MEMORANDUM

Subject: **ZC 05-35 – Consolidated PUD and Zoning Map Amendment
Stanton Square - Stanton and Pomeroy Roads, SE**

ATTACHMENT - A

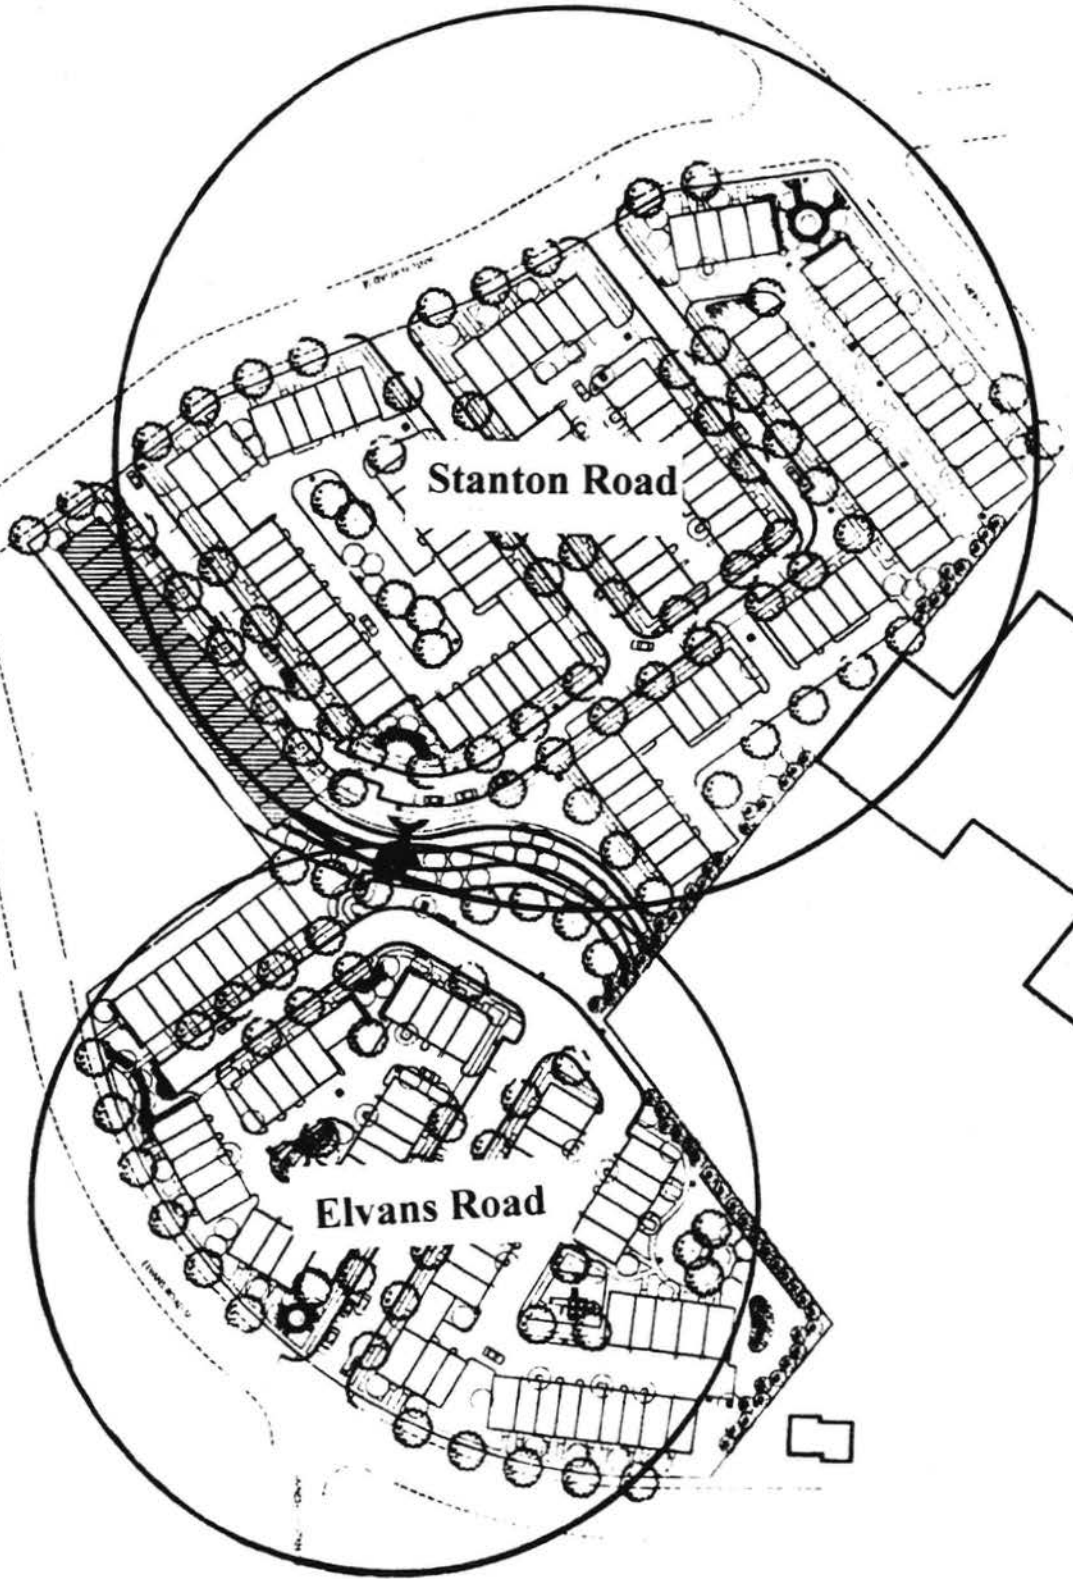
A total of four access points link the project to the adjacent road network with one off Elvans Road, SE across from Gainesville Street, SE, and three access points off Stanton Road, SE. For the purposes of this report the project is separated into two areas linked by a pedestrian walkway, designated the Stanton Road and Elvans Road portions of the project based on public roads providing direct access to each area. (Attachment - A)

ATTACHMENT - C

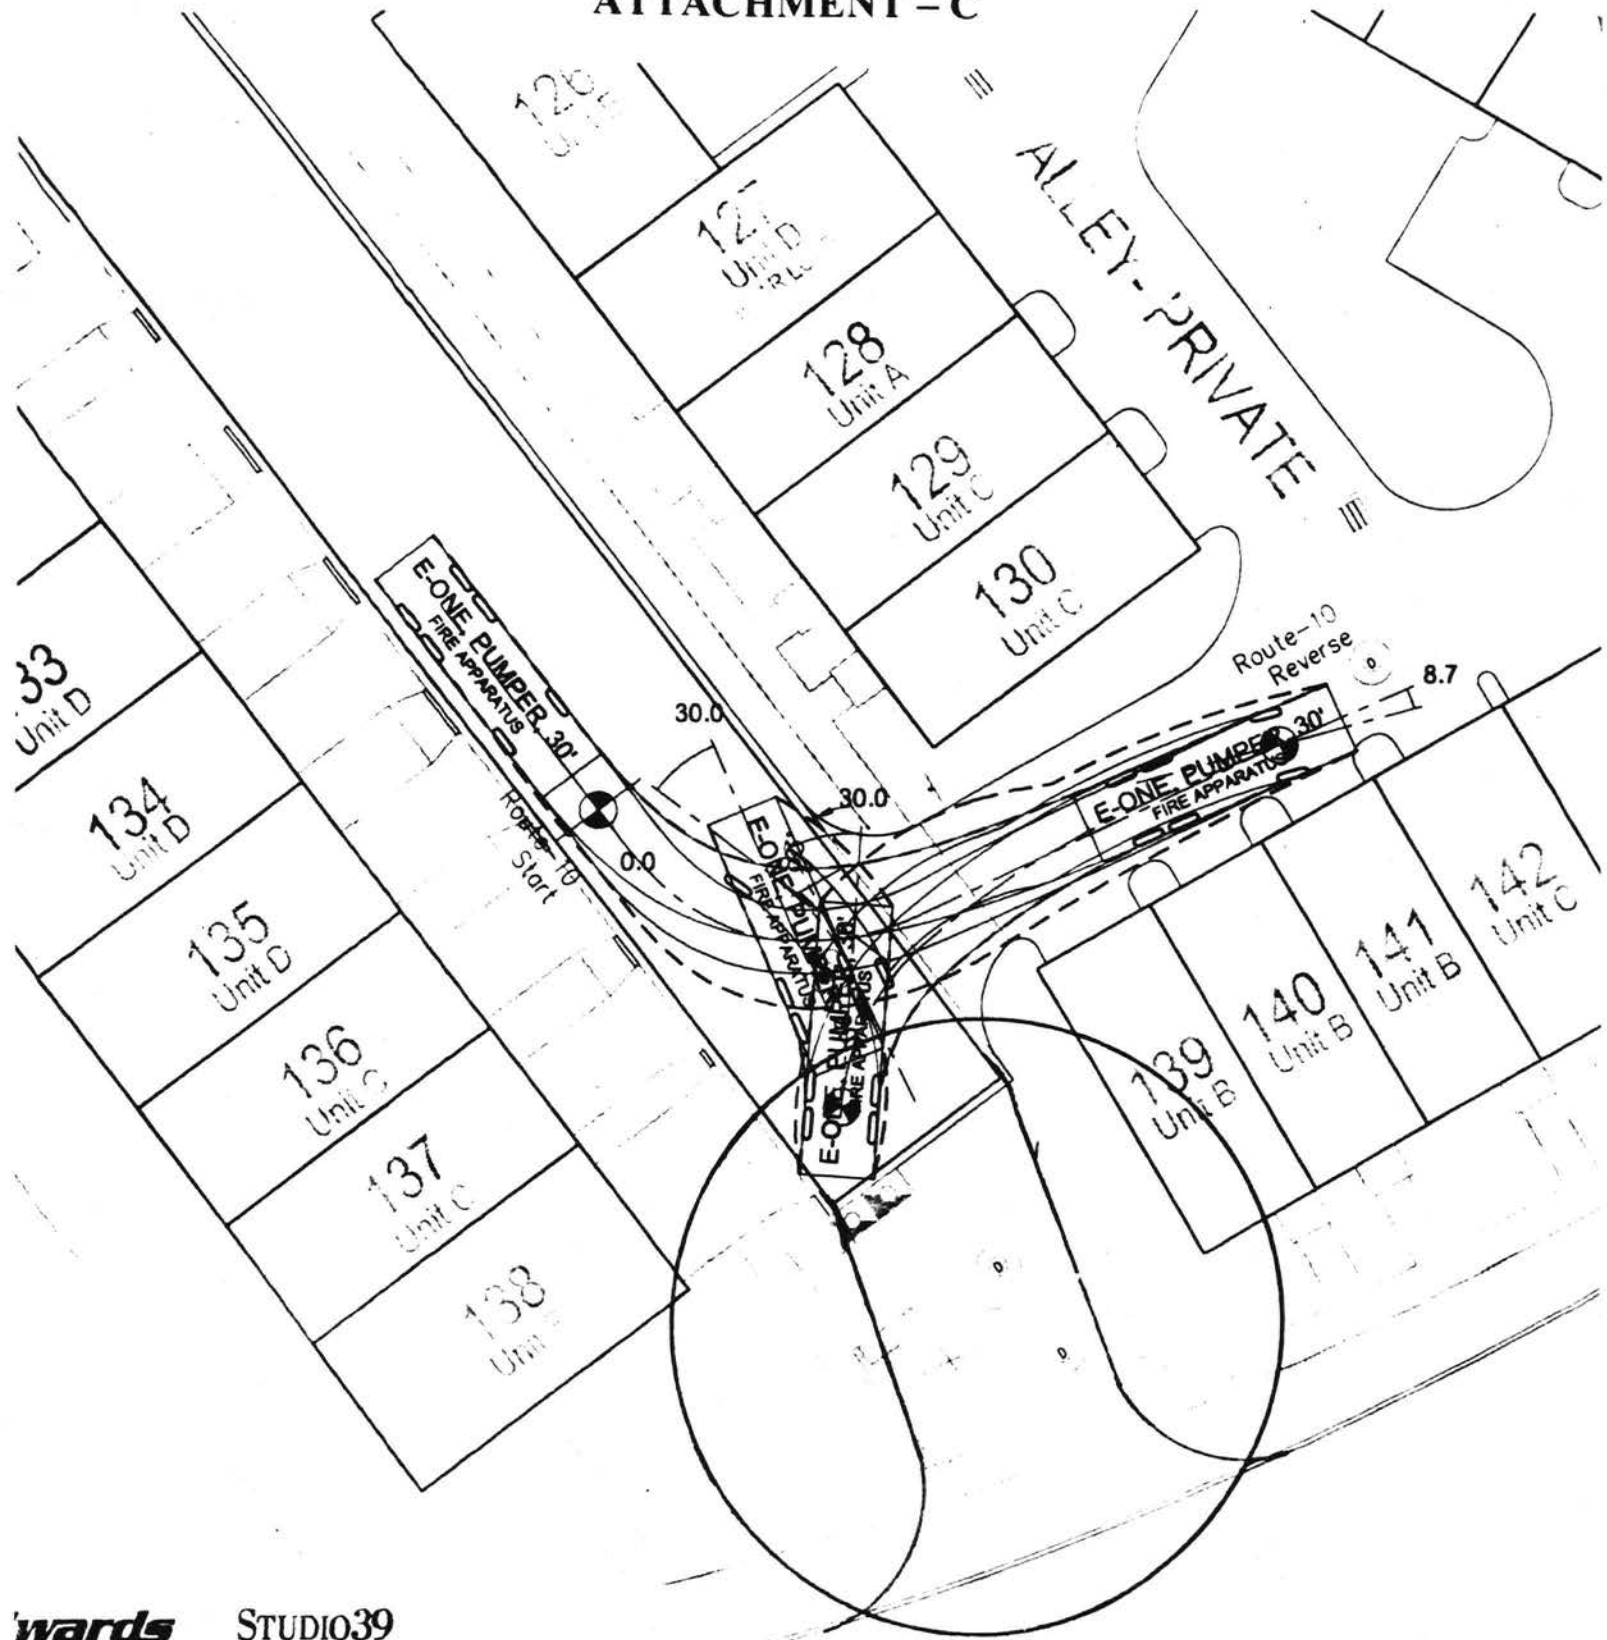
Vehicle circulation within the site is restricted by alleys and roadways that do not connect to streets and dead-end without appropriate areas for vehicles to turn-around. The applicant submitted vehicle tracking diagrams that show the turning for 35 ft. long trash collection trucks, WB-40 tractor trailer trucks and fire trucks. The circulation plan shows both trash and fire trucks heading-in and backing-out of some of the alleys because they dead-end, often crossing private property lines and the curb. The alley system is used to access almost all of the garages for the new town-homes and it is of critical importance that they are accessible at all times. Providing more connections within the site and to surrounding roads will improve overall circulation.
